OHIO TURNPIKE AND
INFRASTRUCTURE COMMISSION

ADDENDUM NO. 4

PROJECT NO. 39-17-01
MAINLINE PAVEMENT RECONSTRUCTION
MILEPOST 90.00 TO MILEPOST 95.90, EASTBOUND
SANDUSKY COUNTY, OHIO

OHIO TURNPIKE AND INFRASTRUCTURE COMMISSION
ADDENDUM NO. 4
PROJECT NO. 39-17-01

CROSSOVER RESTORATION TYPICAL SECTION

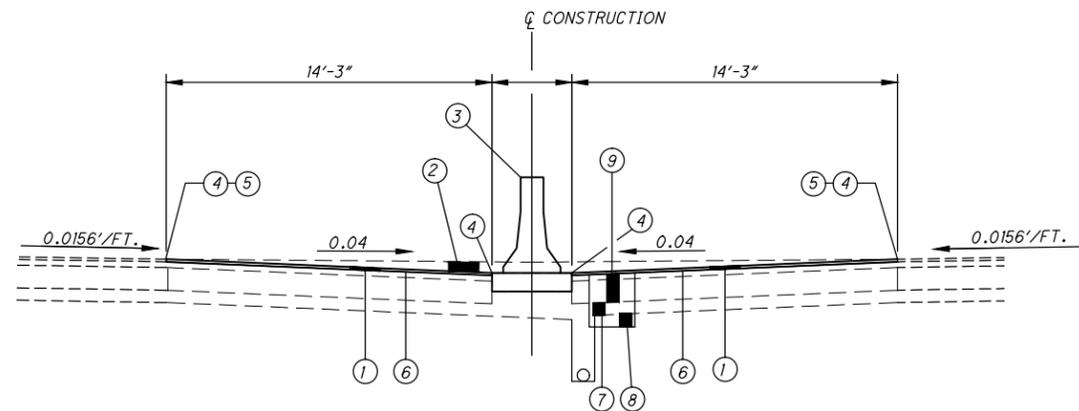
Q#43 Plan sheet 38, note 5 calls for restoration of existing crossover to include removal of slotted drain and temporary drainage structures, and that this work is incidental to SP614 Maintenance of Traffic. What is the required depth of the SP302 and SP304 prior to the 1.5" asphalt resurfacing?

A#43 This Addendum No. 4 clarifies the required thickness of SP302 is approximately 13.5" and the required thickness of SP304 is approximately 7". This value is based from record plans.

SLOPE REPAIR DETAIL 1

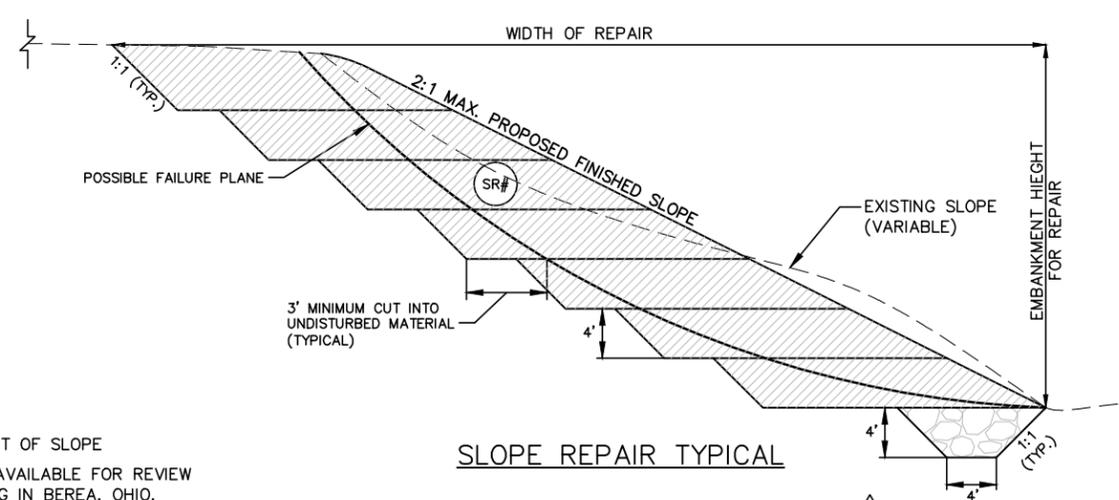
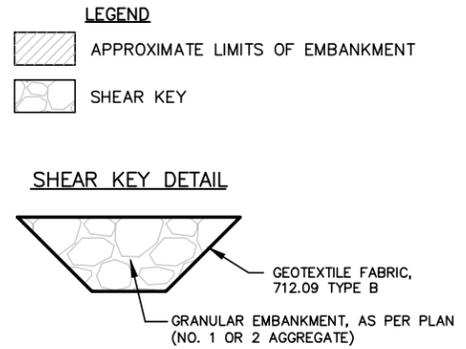
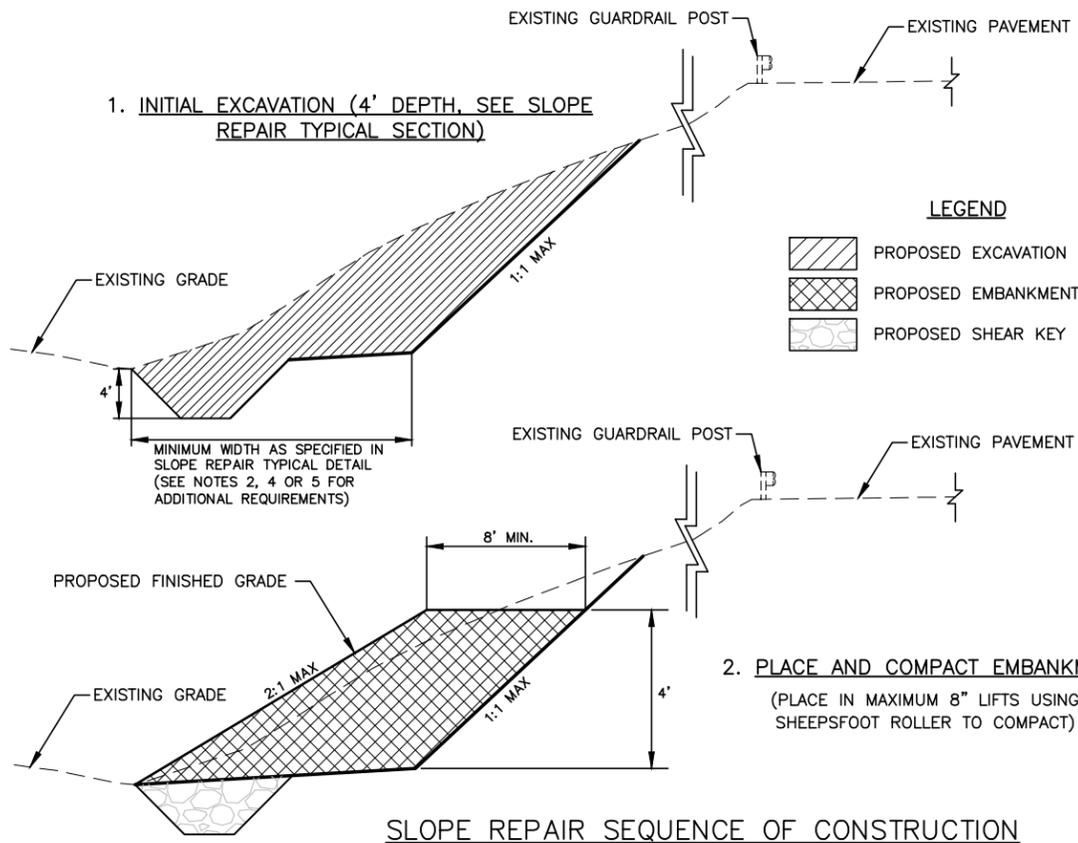
Q#46 In response to addendum 2, plan sheet 9 note on "Linear Grading, As Per Plan"- the second paragraph says to reconstruct the foreslope using 4" topsoil. There is already a bid item for topsoil to cover seeding outside of pavements and shoulders (plan sheet 15 covers seeding/topsoil to 10' beyond shoulder). Does this item include or exclude topsoil?

A#46 Yes. If the Contractor's means and methods results in an area of disturbed earth in addition to the areas described on Plan Sheet 15 of 272, that area shall be covered with a 4-inch depth of topsoil at the Contractor's expense. The linear grading note covers the payment for any additional materials that are needed including topsoil. This Addendum No. 4 modifies the Item Number for Reference No. 51 from Item 659 to Item 653 –

Topsoil, Furnished and Placed (For Slopes) and the associated item number on Plan Sheets 15 and 105 of 272 and Plan Insert Sheet 1 of 1.
